# Technical Bulletin

Board units change

GX-T17

2) Compatibility with Board units and SPST

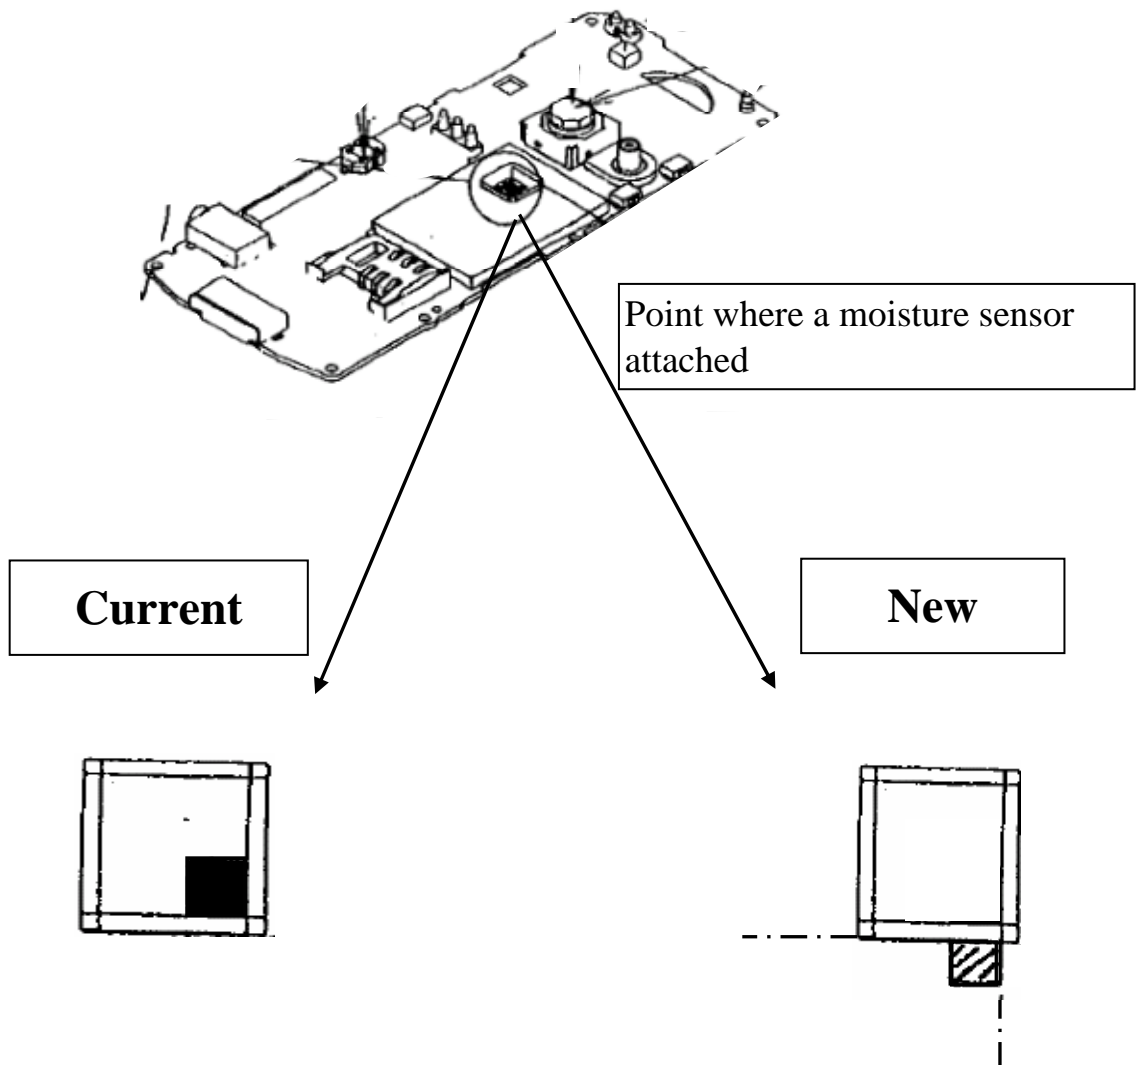
According to the change of GX-T17 board units, its firmware(software) has been also changed. Please perform services according to the following information.

1) Effecton: from May 2006 production

Board unit	Firmware(software)	Operation
Current	current	
	new	
New	current	×
	new

Point where a moisture sensor attached should be different for new ones and current ones.  
Parts code of the board units remain unchanged.

Notice) Board units include keyboards and it is compatible with one another on a unit basis ,  
so you are not allowed to exchange only boards or keyboards between old and new board  
units.
